Model: NAD 30S/30/40		Date: 31-May-98	No: 3
Subject: Service Manual Corrections		Prepared by: Y. Furuya	
From: Technical Service Department.			
Classification:	<input type="checkbox"/> Troubleshooting	<input type="checkbox"/> Part information	<input type="checkbox"/> Action required
	<input type="checkbox"/> Mechanical	<input type="checkbox"/> Electrical	<input checked="" type="checkbox"/> Service manual revision
	<input type="checkbox"/> Paper path	<input type="checkbox"/> Transmit/receive	<input type="checkbox"/> Retrofit information
	<input type="checkbox"/> Other (       )

This bulletin contains corrections for the Fax Option Type 450 service manual.

Model: NAD 30S/30/40 FAX Option Type 450		Date: 20-Jan-99	No.: 01
Subject: Software Release Information		Prepared by: E.Fukuyama	
From: GTSS Field Information Depot			
Classification:	<input type="checkbox"/> Troubleshooting <input type="checkbox"/> Part information <input type="checkbox"/> Action required <input type="checkbox"/> Mechanical <input type="checkbox"/> Electrical <input type="checkbox"/> Service manual revision <input type="checkbox"/> Paper path <input type="checkbox"/> Transmit/receive <input type="checkbox"/> Ret

## Chapter 3

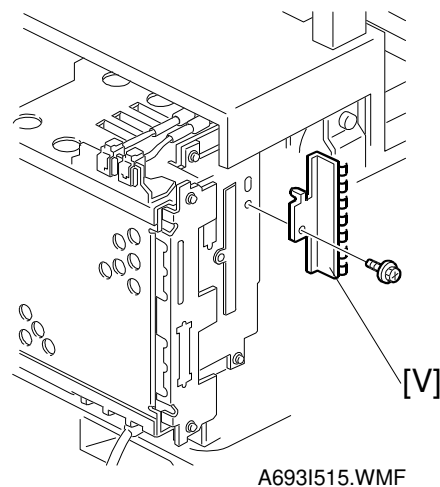
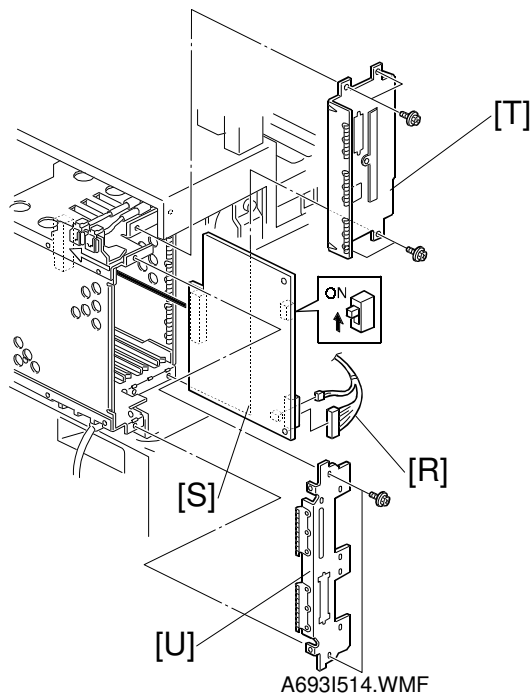
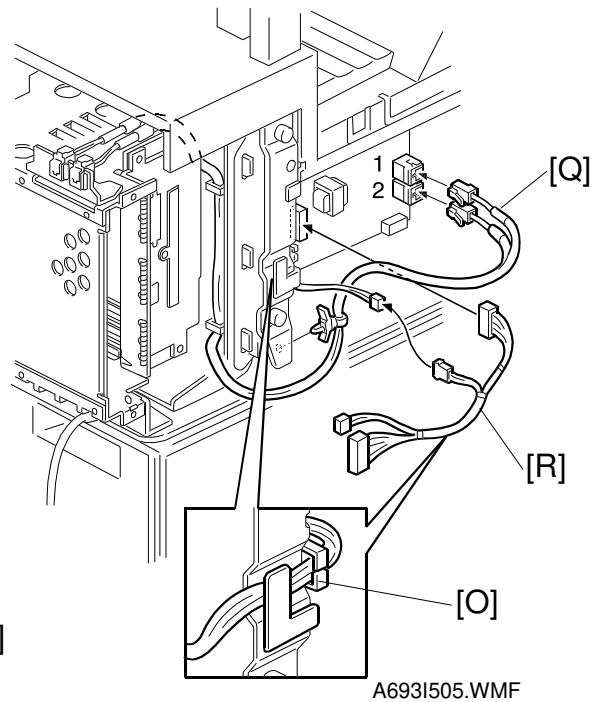
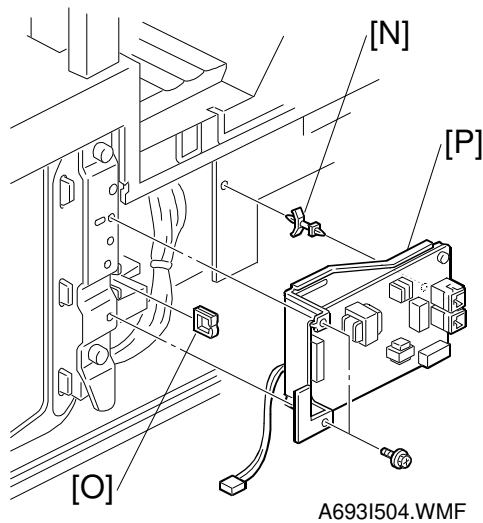
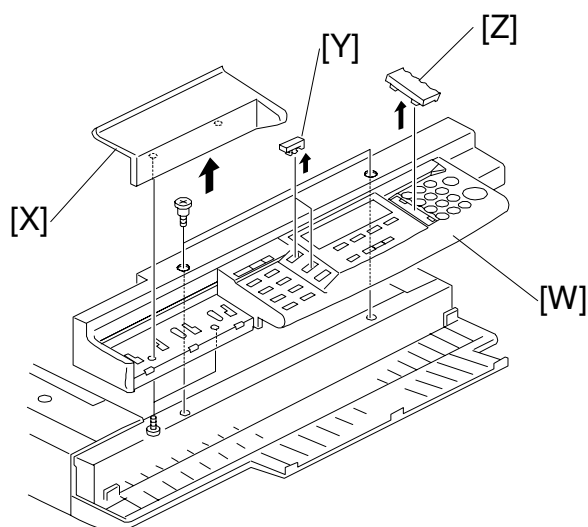
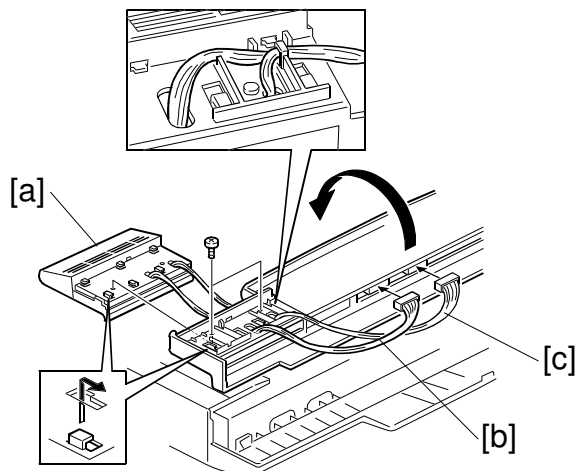
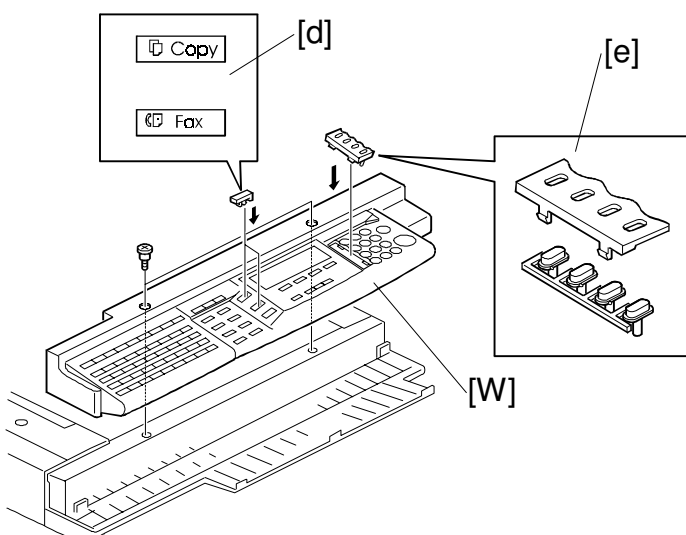
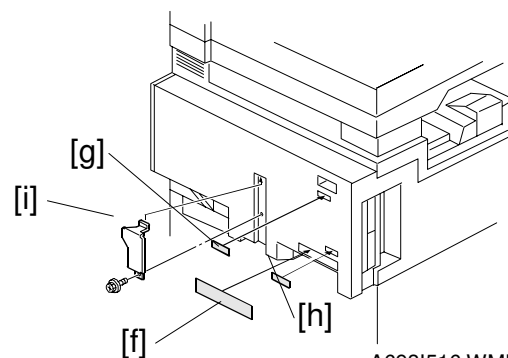
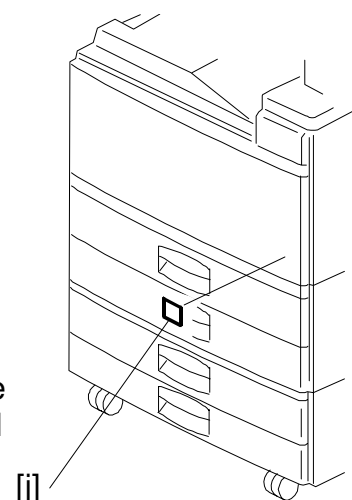
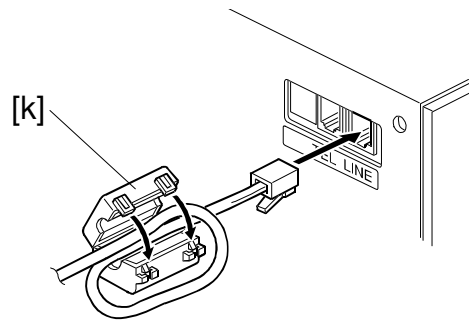
### ***Problem***

- 1) The installation procedure was not suitable for the Taiwan version
- 2) A bracket must be removed before installing the expansion box; this was not mentioned.
- 3) The procedure for attaching the PTT approval label was missing.

### ***Correction***

- 1) The installation procedure has been modified for all versions, including Taiwan.
- 2) Missing steps have been added. (Items 2 and 3 above; refer to pages 2 to 5.)
